RE: Data Response, Set 1D (Optimization)
Ivanpah Solar Electric Generating System (07-AFC-5)

Ivanpah Solar Electric Generating System (ISEGS)

Data Response, Set 1D

**(Response to Data Requests: Project Description, Air Quality,
Biological Resources, Land Use, Soil & Water, and Visual
Resources)**

FIGURE DR97-2bR
SIMULATED VIEW OF IVANPAH 1 FROM
KOP 4 (Yates Well Road Exit off I-15)
IVANPAH SOLAR ELECTRIC GENERATING SYSTEM

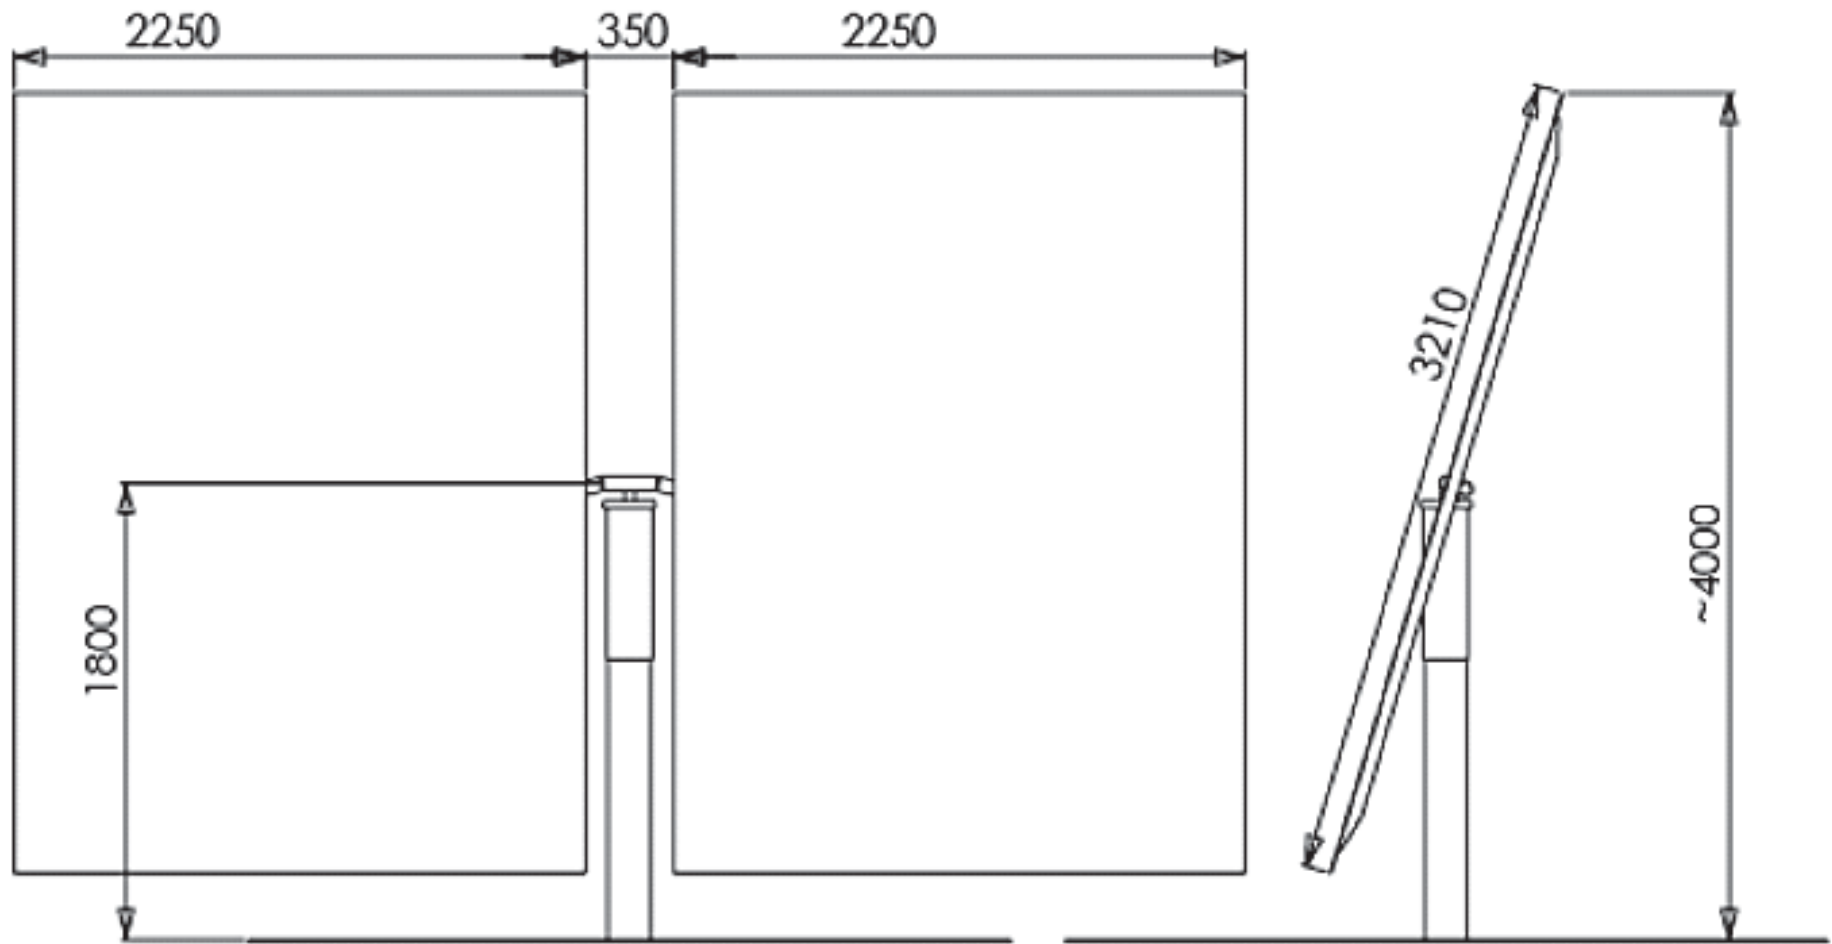
Figure DR97-2bR shows the KOP 4 view of Ivanpah 1 from the Yates Well Road exit. Similar to that described for KOP 1, when compared to the four power towers (Figure DR97-2b previously submitted in Data Response, Set 1A), the project optimization is more prominent in the view due to the larger taller structure and the greater visibility of the heliostat field. This view is from approximately 1.2 miles away from the eastern boundary of the Ivanpah 1 plant site, and is the closest I-15 location to the project. This viewing location is not considered a sensitive receptor

1. LAND/WATER		2. VEGETATION	3. STRUCTURES
FORM	No change in the foreground or background views would occur, as shown in Figure DR97-2bR. No water exists in this area, so no change in water bodies would occur. The land surface at the project site would be modified by grading and the addition of project facilities.	No change would occur to the vegetation in the foreground or background from the project. Vegetation would be removed to allow for the installation of the power tower and field of mirrors, but the vegetation at the project site is not visible from this viewpoint.	The project would add human-made forms to the landscape, as shown in Figure DR97-2bR (power tower in the midst of a field of mirrors).
LINE	No change in ridgeline of the mountains or the horizontal line where the desert meets the I-15 pavement. The horizontal line at the base of the mountains is obscured by the presence of project facilities. Less of the flat terrain in the project area is seen due to the presence of project facilities.	No change in the foreground or background vegetation would occur. As indicated above, vegetation is not visible at the project site from this KOP.	Adding the project features (a power tower and a field of mirrors) to the landscape would add both vertical and horizontal lines to the view (see Figure DR97-2bR).
